SUBJECT: M20TN ENGINE ISOLATOR MOUNT INSPECTION

MODELS/ SN M20TN - 31-0002 thru 31-0023 and 31-0025 thru 31-0127
AFFECTED:

TIME OF COMPLIANCE: **INITIAL INSPECTION WITHIN 10 FLIGHT HOURS / NEXT 100 HR INSPECTION**

Figure SB M20-316-1 - ENGINE MOUNT AND HARDWARE INSTALLATION

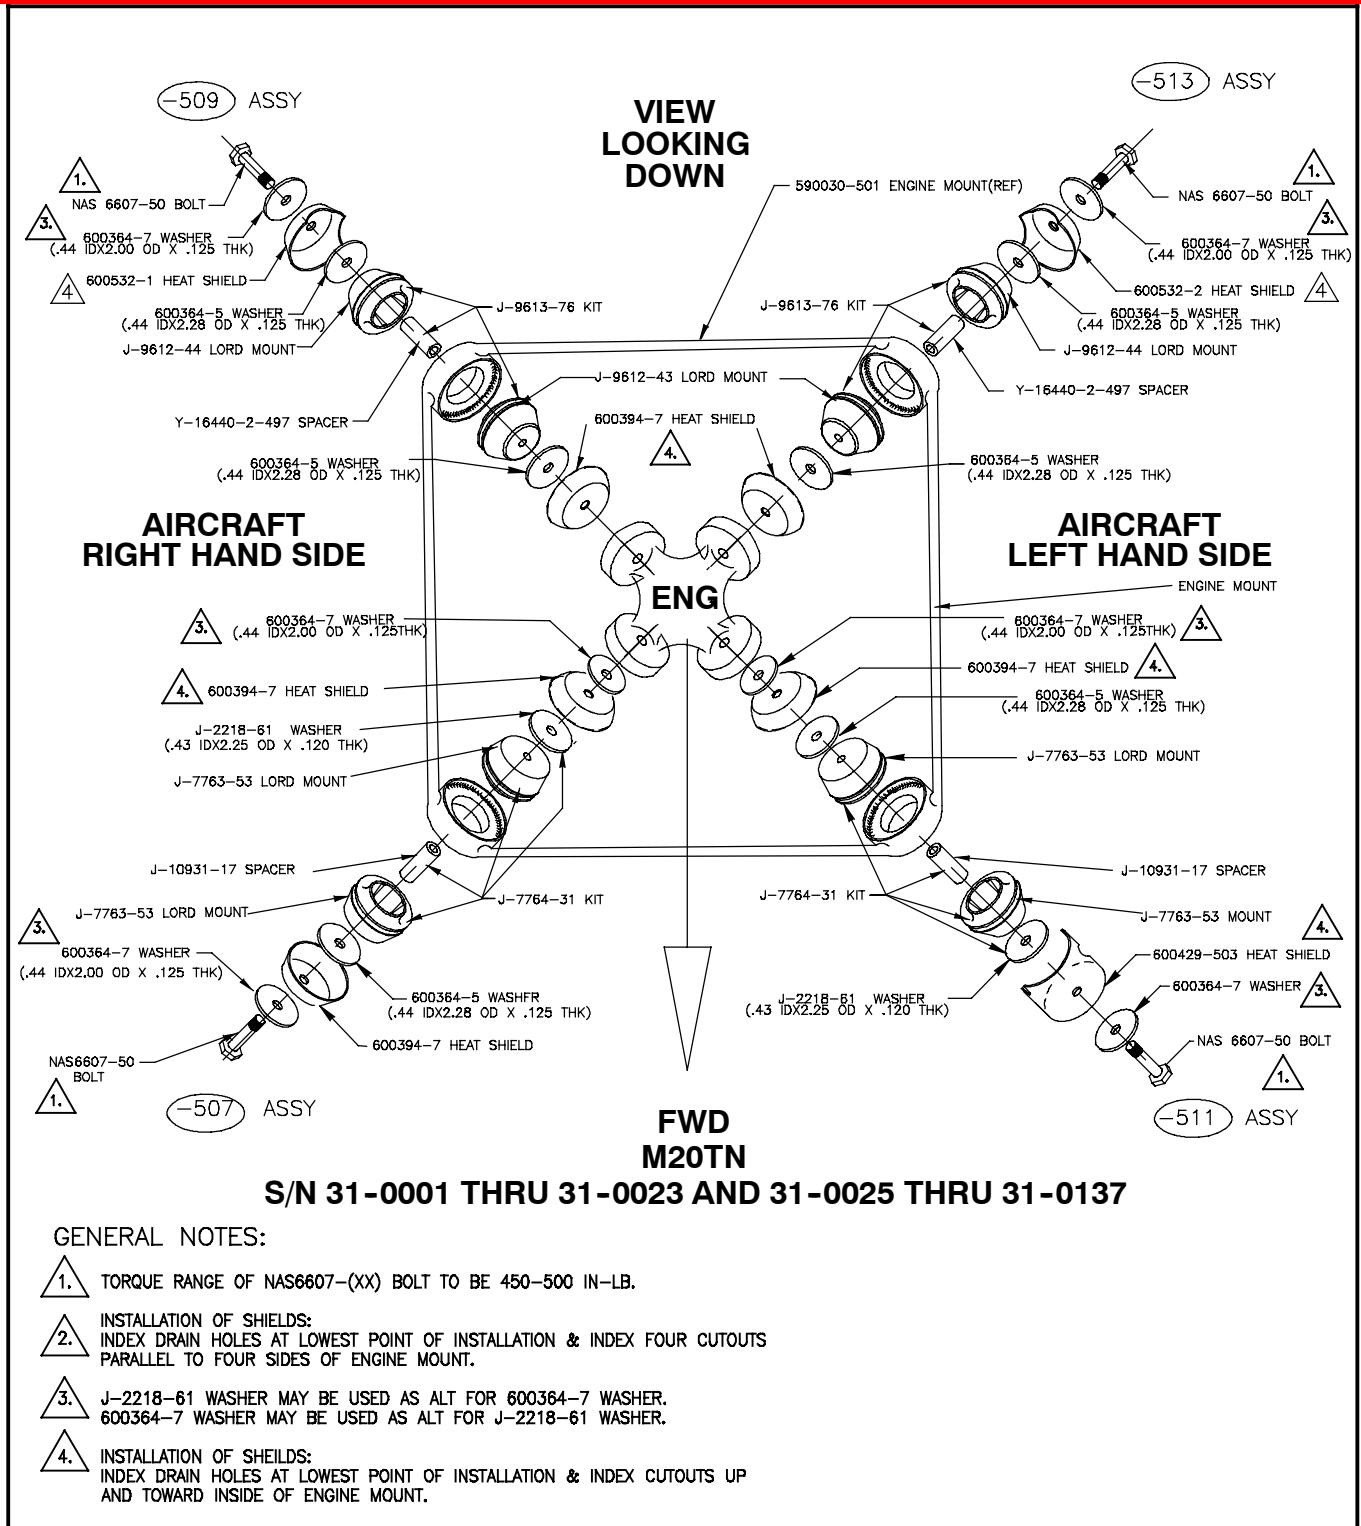
INTRODUCTION: There has been a report from the field of improper clamp-up and distortion of the mount isolators, as well as extreme difficulty in the re-installation in general. Both the service manual and illustrated parts catalog incorrectly identified the mounting sequence (refer to Mooney Service Instruction M20-121) and will be updated at their next revision cycle to reflect this information. Because the exact history of this installation is unknown, an inspection is required for field M20TN's to verify engine installation.

- 1.10. If movement has been determined, continue to next steps of this service bulletin.
- 1.11. Refer to **STEP 2** and remove each isolator (one at a time), verify correct and/or stack-up as shown in Figure SB M20-316-1 (Refer to MAC Service Instruction M20-121).

The arrangement of engine isolator mounts is extremely critical. Make certain they are arranged as shown in Figure SB M20-316-1.

The arrangement of engine isolator mounts is extremely critical. Make certain they are arranged as shown in Figure SB M20-316-1.

- 2.13. Correctly position each heat shield in place per figure 1, index drain holes at lowest point of installation & index cutouts parallel to sides of engine mount. Make sure heat shields are oriented to prevent chaffing or interference on engine mount or engine components.
- 2.14. Install both retaining bolts, washers and torque to specification - refer to Figure SB M20-316-1.
- 2.15. Reinstall top and bottom cowling, refer to MAC Service and Maintenance Manual.
- 2.16. Complete log book entry.

Figure SB M20-316-2 - INSTALL ENGINE ISOLATOR MOUNTS AND HARDWARE

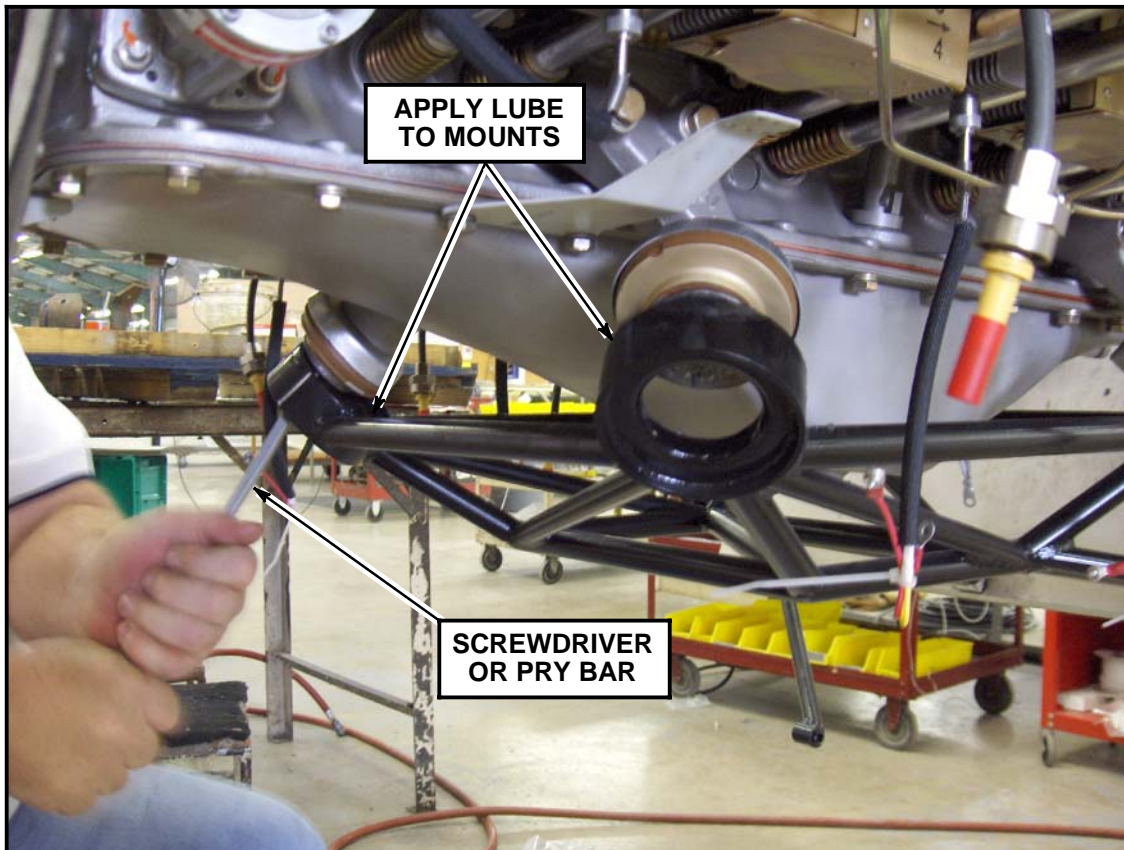
- 2.8. Use "dummy" bolts (NAS6607-15 or equivalent) and washers to secure each of the upper halves of isolator mounts. Ensure upper washer and heat shield are installed between isolator and engine motor mount castings (4 places). Tighten bolts to compress rubber mounts to approximate thickness shown in Figure SB M20-316-2.

- 2.11. Use a large flat screwdriver to pry mounts into cups. This step requires a considerable amount of patience and "elbow grease" - refer to Figure SB M20-316-2.
